Remarks

The attached replacement sheets of drawings includes changes to Figures 1, 2, 4, 5, and 6. Replacement sheet 1 replaces original sheet 1 including changes to Figures 1 and 2. In Figure 1, reference numeral 160 is corrected to 150. In Figure 2, the cross hatching is expanded for clarity. In addition, the cross hatching for seal members 134, and 146 is changed for clarity as suggested by the Examiner.

S/N: 10/789,856 DOCKET: 18005 (AT: 20958-38)

FIG. 1

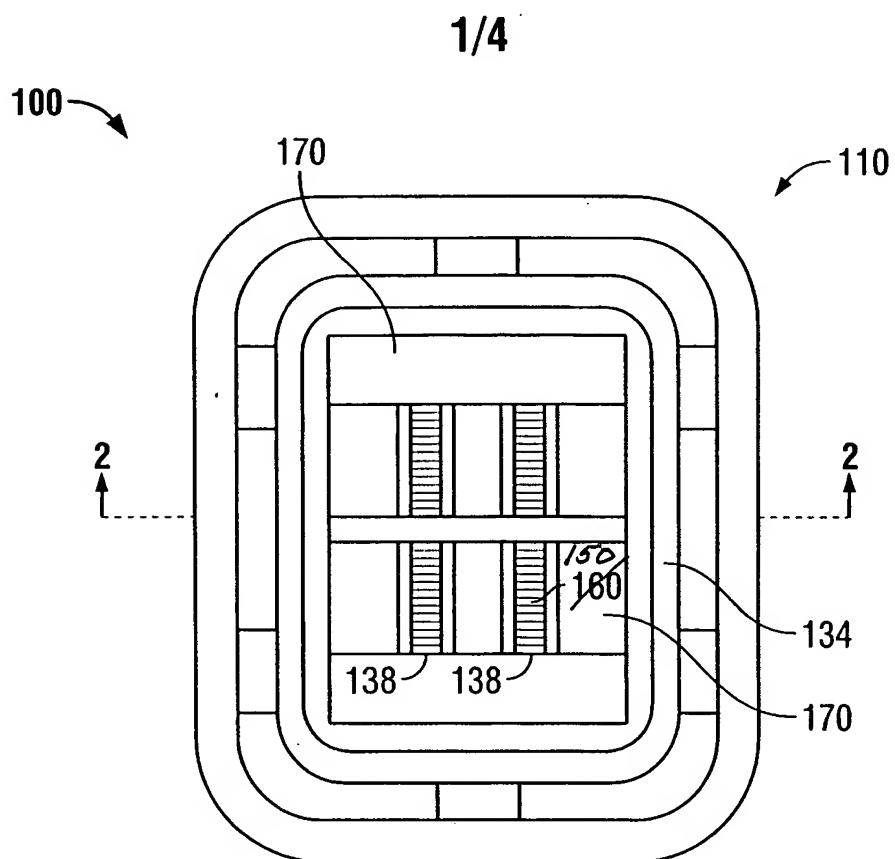
The objections to the drawings are respectfully traversed. Submitted herewith are replacement drawing sheets incorporating changes to Figures 1, 2 4, 5, and 6 as indicated above. In Figure 1, the reference numeral 160, which was not referenced in the description, is corrected to 150. In Figures 2, 4, 5, and 6, the cross hatching is changed for clarity, adopting the Examiner's suggestions. No new matter has been added.

FIG. 4

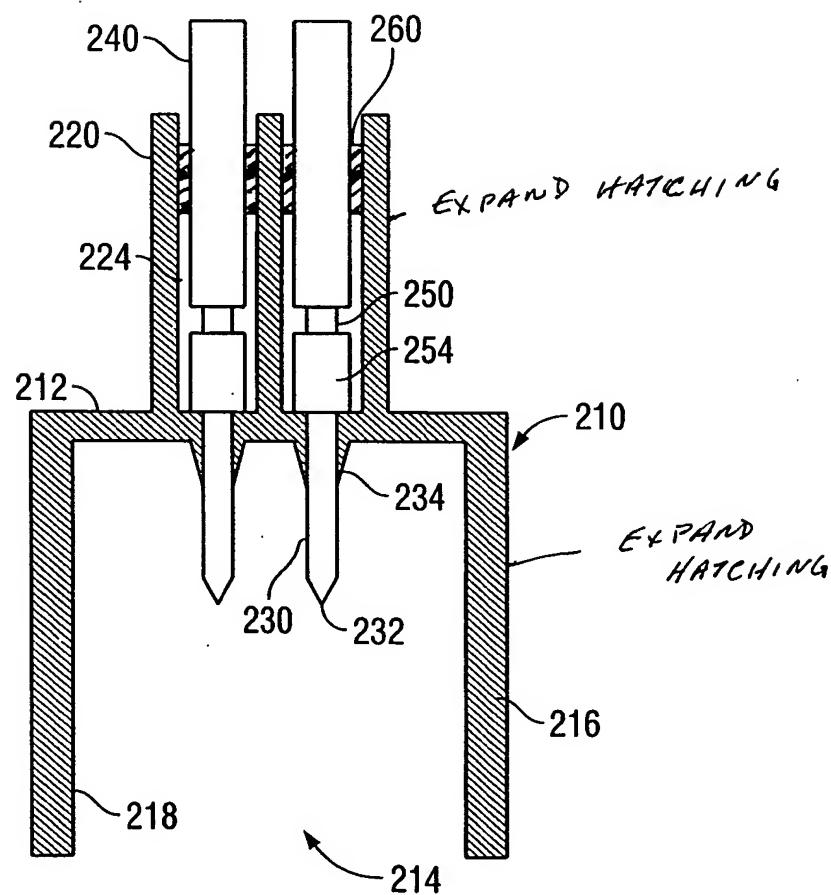
Replacement sheet 2 replaces original sheet 2 including changes to Figure 4. In Figure 4, the cross hatching is expanded for clarity. In addition, the cross hatching for seal members 260, is changed for clarity as suggested by the Examiner.

FIG. 5

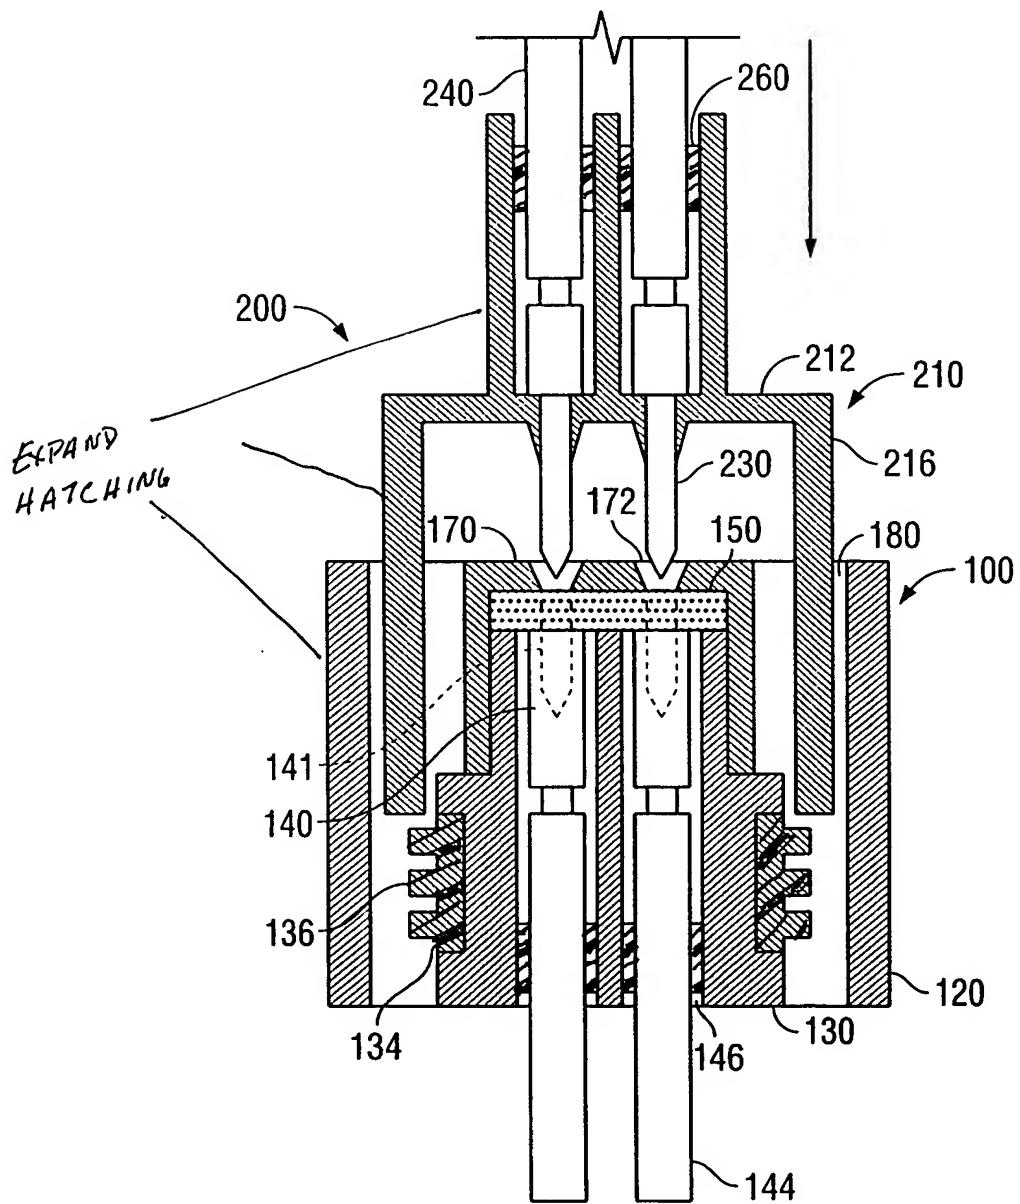
Applicant notes that, with respect to Figures 2, 5, and 6, the gel material (150) has sufficient structural integrity, that the gel material does not flow into the chambers (138) as discussed in paragraph 0016 in the description. Similarly, the gel material does not flow into the beveled areas (172). These areas therefore are not changed in the drawings.

Replacement sheet 3 replaces original sheet 3 including changes to Figure 5. In Figure 5, the cross hatching is expanded for clarity. In addition, the cross hatching for seal members 134, 146, and 260 is changed for clarity as suggested by the Examiner.

FIG. 6

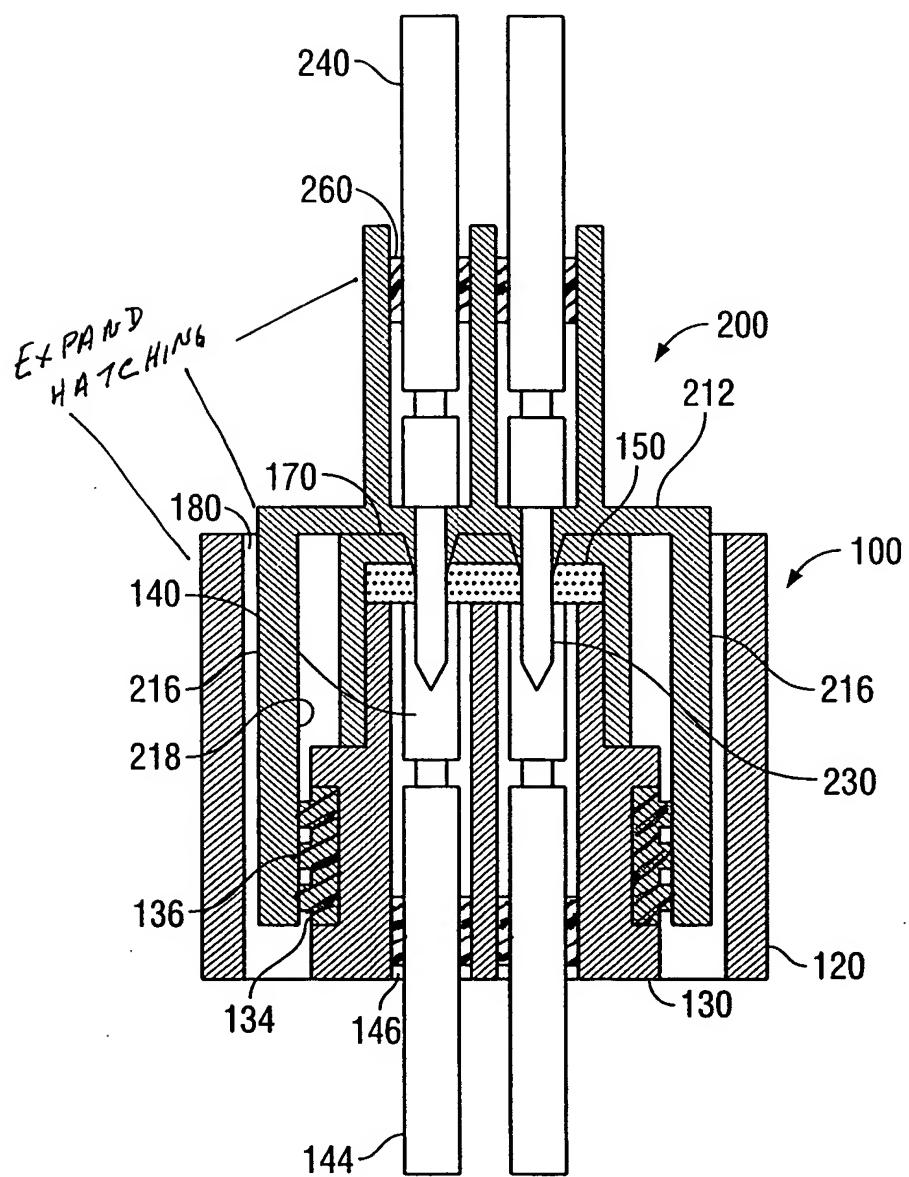
Replacement sheet 4 replaces original sheet 4 including changes to Figure 6. In Figure 6, the cross hatching is expanded for clarity. In addition, the cross hatching for seal members 134, 146, and 260 is changed for clarity as suggested by the Examiner.
